Economic Commission for Europe**Inland Transport Committee****World Forum for Harmonization of Vehicle Regulations****179th session**

1958 Agreement:**consideration of draft amendments to existing
UN Regulations submitted by GRSP****Proposal for Supplement 3 to the 03 series of amendments to
UN Regulation No. 129 (Enhanced Child Restraint Systems)****Submitted by the experts from the Working Party on Passive Safety***

Supplement 3 the 03 series of amendments to UN Regulation No. 129 (Enhanced Child Restraint Systems)

Universal booster cushion

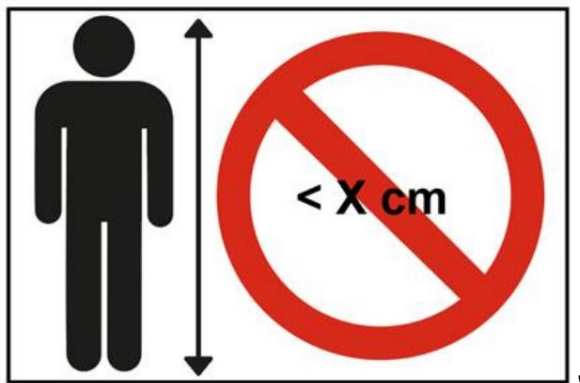
Insert new paragraphs 4.8.3. to 4.8.5., to read:

- "4.8.3. Universal booster cushion Enhanced Child Restraint Systems shall have a permanently attached label with the following information visible to the person installing the Enhanced Child Restraint System in the car:

Figure 1
Measurement device to check the Sitting Height

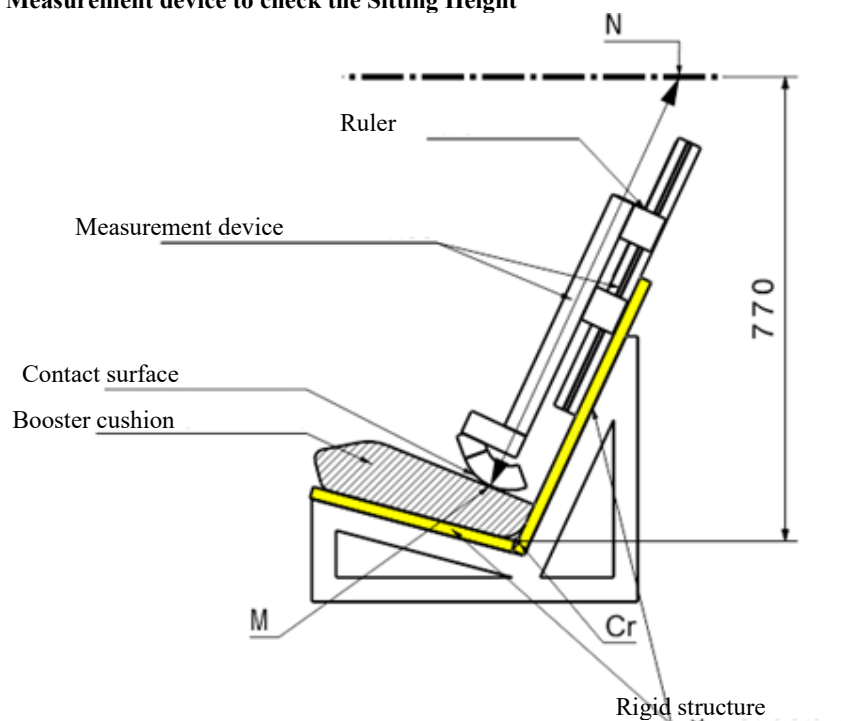
"6.1.3.6. For booster cushions, type approval shall not be granted for a stature below 125 cm. Booster cushions shall not be declared for use below a stature of 125 cm.

Booster cushions shall ensure that the top of the child's head is at or above a horizontal plane at 770 mm vertically from the Cr axis when seated on the test bench described in Annex 6.

The procedure to check if a booster cushion fulfils this requirement is outlined as follows (See figure 1 below):

- (a) A simulated test bench shall be used for the assessment. The simulated bench shall have the same geometry as the test bench defined in Annex 6 of this Regulation, including the seat cushions. However, the width of the simulated bench may be reduced, if the width is between 500 and 800 mm, as shown in Annex 25. The simulated test bench shall be of rigid construction and shall not deform when using the measuring device defined in Annex 25.

- (b) A rigid structure is attached to the simulated test bench and holds a sliding part. A horizontal plane that is located at a vertical distance of 770 mm from the Cr axis is defined.

- (c) The booster cushion shall be placed on the simulated test bench with its centreline aligned with the centreline of the test bench and the rear surface of the booster cushion contacting the backrest of the test bench.

- (d) If ISOFIX attachments are present these shall be latched with the test bench lower ISOFIX anchorages. An additional force of $135 \pm 15\text{N}$ shall be applied in a plane parallel to the surface of the simulated test bench. The force shall be applied along the centreline of the Enhanced Child Restraint System and at a height of no more than 100 mm above the simulated test bench seat surface.

- (e) The measurement device is extended downwards parallel to the simulated test bench backrest, until it is stopped by the booster seat cushion.

- (f) The measured distance between the two points M and N (Figure 1) represents the sitting height of a child who will use the booster cushion. The corresponding value is displayed by a ruler that is provided with the device as shown in Figure 2.

1. Arrangements of the approval mark

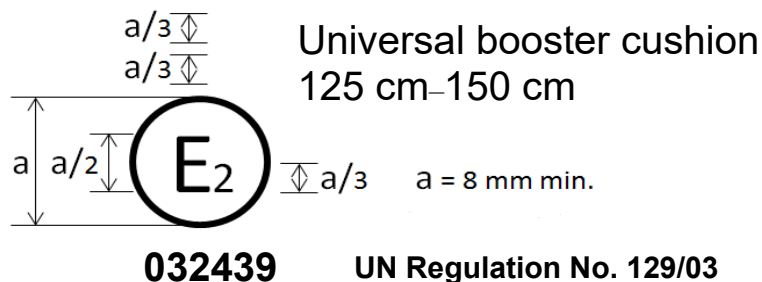
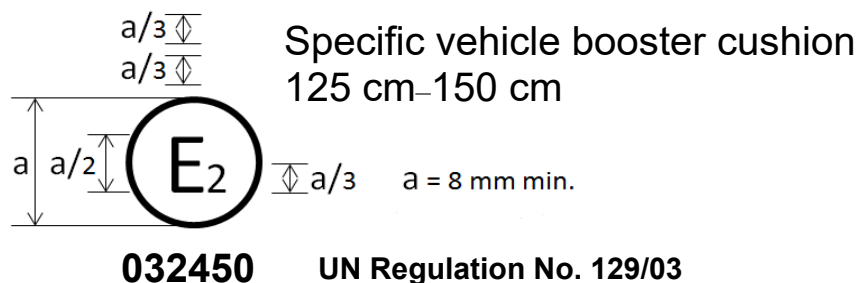
Annex 2, amend to read:

The Enhanced Child Restraint System bearing the above approval mark can be fitted in any i-Size seating position and Universal seating position, and used for the 125 cm–150 cm size range; it is approved in France (E 2) under the number 032439. The approval number indicates that the approval was granted in accordance with the requirements of the Regulation concerning the approval of Enhanced Child Restraint Systems used on-board of motor vehicles as amended by the 03 series of amendments. In addition, the name of the Regulation is to be identified on the approval mark followed by the series of amendment according to which the approval has been granted.

The Enhanced Child Restraint System bearing the above approval mark is a device not capable of being fitted in every vehicle but is capable of being used for the 125 cm–150 cm size range; it is approved in France (E 2) under the number 032450. The approval number indicates that the approval was granted in accordance with the requirements of the Regulation concerning the approval of specific vehicle booster cushion Enhanced Child Restraint Systems used on-board of motor vehicles as amended by the 03 series of amendments. In addition, the name of the Regulation needs to be identified on the approval mark followed by the series of amendment according to which the approval has been granted.

Device to measure the booster cushion height

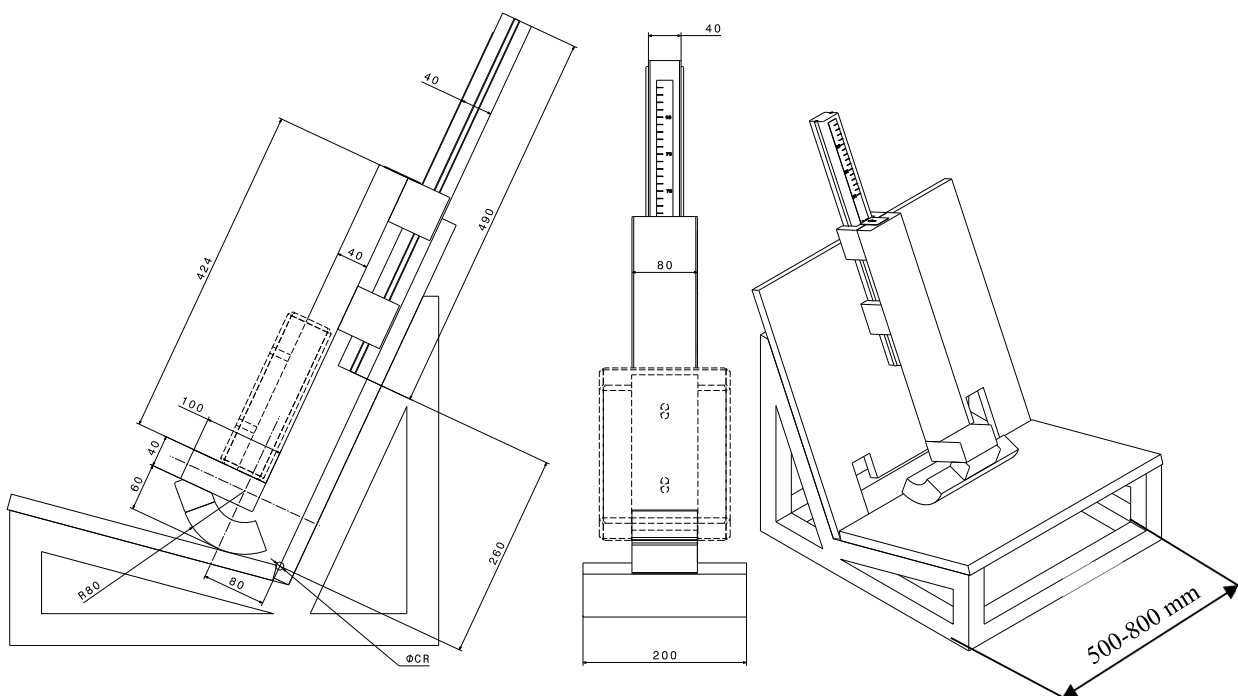
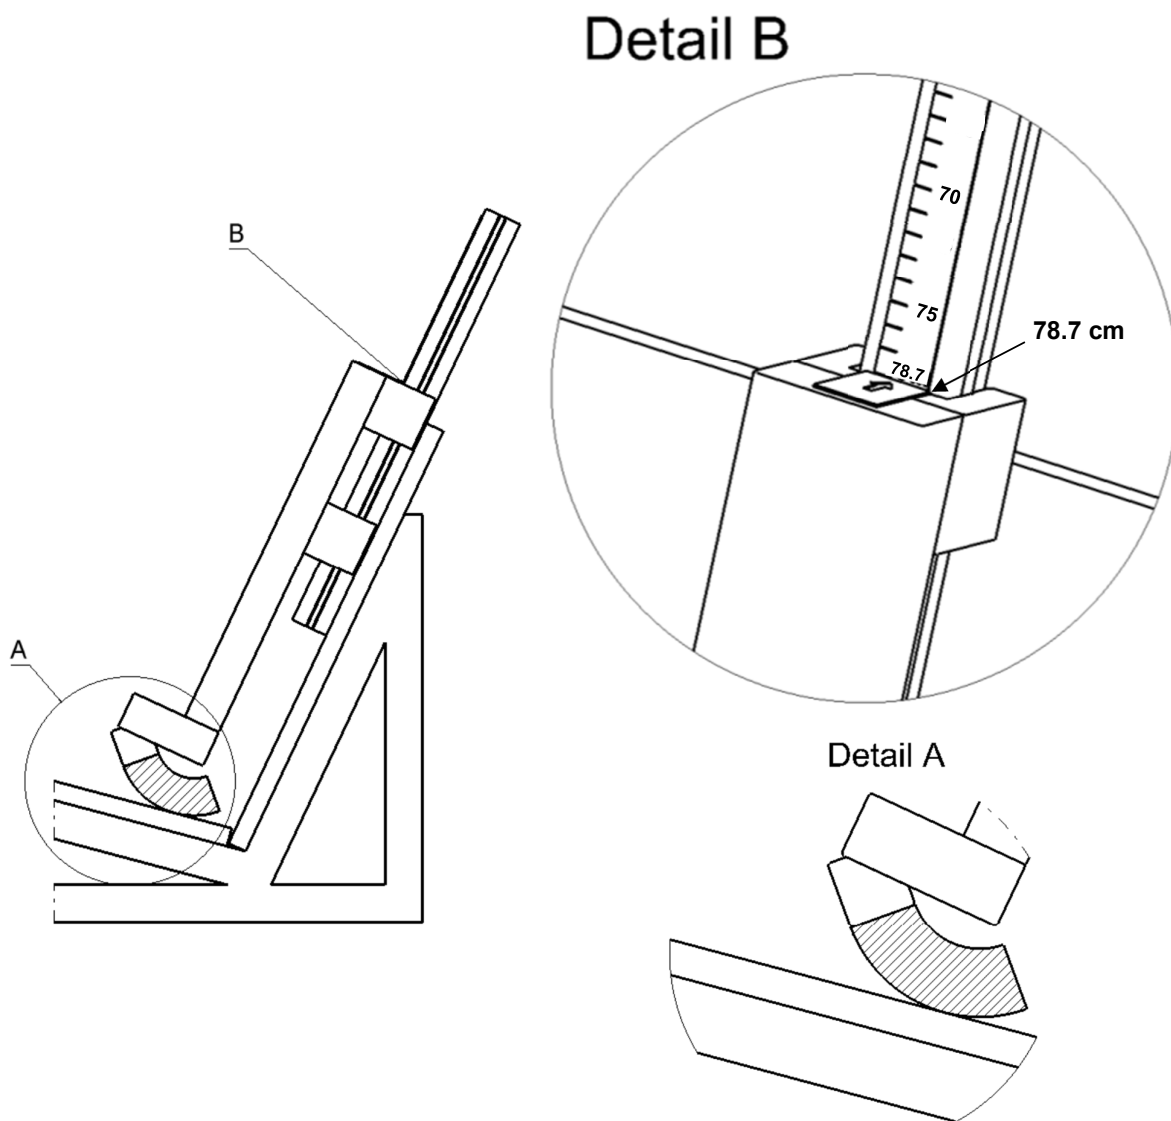
Insert new Annex 25, to read:

The mass of the device shall be 15kg +/-1kg

Calibration of the measurement scale

To calibrate the ruler of the measurement device, its structure shall contact the supporting surface (Detail A). In this configuration, the scale shall show the calibration value of 78.7 cm (Detail B).

The calibration of the ruler is based on the sitting height of the Hybrid III 5th percentile dummy seated on the test bench defined in Annex 6 of this Regulation. When this dummy is seated on the test bench, the top of the head is 77.0 cm from the Cr axis. The nominal sitting height of the dummy is 78.7 cm. Therefore, 78.7 cm is used as the calibration value.

Figure 1
Manikin block (based on truncated P10)
Material: Expanded polystyrene (EPS) (40 to 45 g/l) or alternative non-deformable material

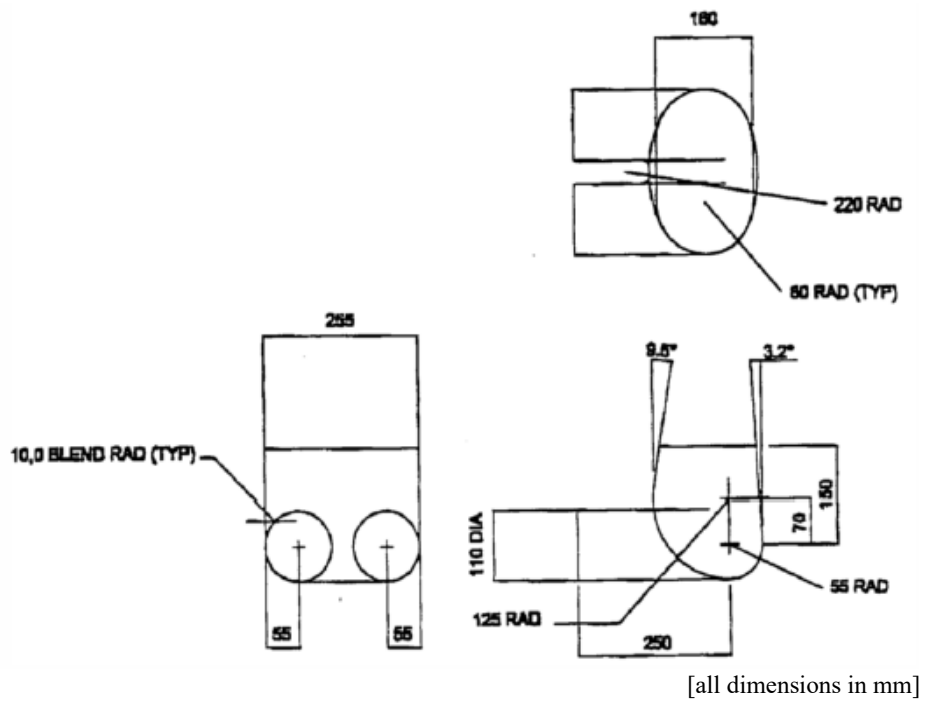
Insert new Annex 26, to read:

Place a cotton cloth on the seating surface of the test bench. Position the booster cushion on the test bench, position the lower torso body block as described in Annex 26, Figure 1, on the seating surface, fit and apply the 3-point adult safety-belt and tension as prescribed in paragraph 7.1.3.5.2.2. With a strip of 25 mm-wide webbing or similar, tied around the booster, apply a load of 250 ± 5 N in the direction of arrow A (see Annex 26, Figure 2), in line with the seating surface of the test bench.

Figure 2
Booster pull test using manikin block

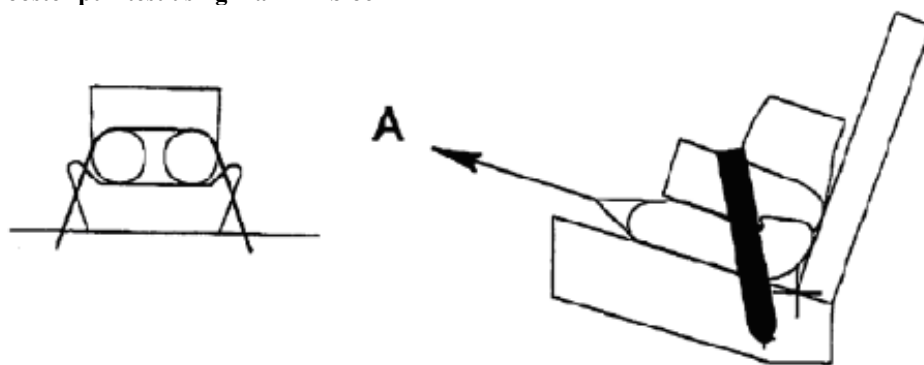
The booster cushion shall not be pulled completely out of the 3-point adult safety-belt and shall remain under the body block during the test."
